SEWAGE DISPOSAL SYSTEM

MARYLAND STATE DEPARTMENT OF HEALTH

SUBDIVISION Linden Chapel Hills

LOT 14, Blk. A, Sec. 5

PERMIT CARD

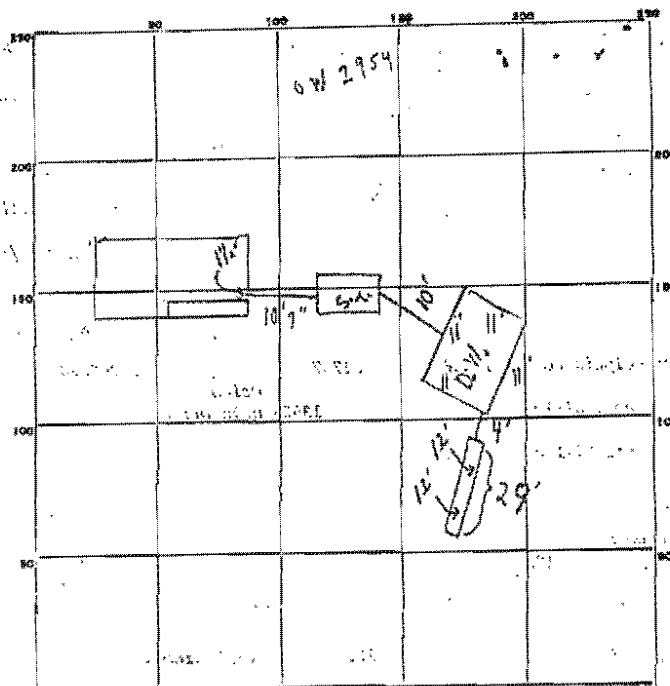
5/13/80 CHECKED - TRENCH SHORT NEED 8' MORE IN LENGTH

(2) TRENCH NOW 29' LONG. HOLD FOR FINAL ON TRENCH - OK TO COVER

FROM HOUSE TO DRYWELL. C.B.J. 5/14/80 SYSTEM COMPLETE.
